SUBJECT: Public Works Conditions of Approval

T-6502 / P24-04042 a private development / public development

7270 E McKinley Ave

De Young Properties / Gateway Engineering

EXHIBIT NO. 1

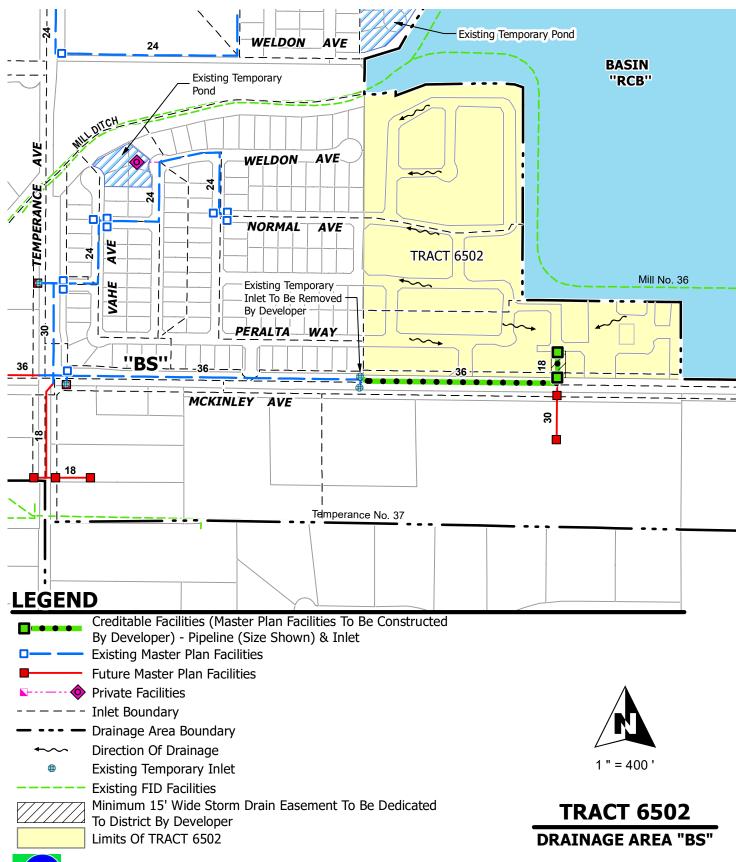
Approval of this development shall be conditioned upon compliance with these District Requirements. 1. **a.** Drainage from the site shall **X b.** Grading and drainage patterns shall be as identified on Exhibit No. 1. c. The grading and drainage patterns shown on the site plan conform to the adopted Storm Drainage and Flood Control Master Plan. The proposed development shall construct and/or dedicate Storm Drainage and Flood Control Master Plan facilities 2. located within the development or necessitated by any off-site improvements required by the approving agency: Developer shall construct facilities as shown on Exhibit No. 1 as MASTER PLAN FACILITIES TO BE _X_ CONSTRUCTED BY DEVELOPER. None required. 3. The following final improvement plans and information shall be submitted to the District for review prior to final development approval: \mathbf{X} **Grading Plan** \mathbf{X} Street Plan X Storm Drain Plan X Water & Sewer Plan X Final Map \mathbf{X} Drainage Report (to be submitted with tentative map) Other None Required 4. Availability of drainage facilities: a. Permanent drainage service is available provided the developer can verify to the satisfaction of the City that runoff can be safely conveyed to the Master Plan inlet(s). **b.** The construction of facilities required by Paragraph No. 2 hereof will provide permanent drainage service. X c. Permanent drainage service will not be available. The District recommends temporary facilities until permanent service is available. ____ **d.** See Exhibit No. 2. 5. The proposed development: \mathbf{X} Appears to be located within a 100 year flood prone area as designated on the latest Flood Insurance Rate Maps available to the District, necessitating appropriate floodplain management action. (See attached Floodplain Policy.) Does not appear to be located within a flood prone area. The subject site contains a portion of a canal or pipeline that is used to manage recharge, storm water, 6. and/or flood flows. The existing capacity must be preserved as part of site development. Additionally, site
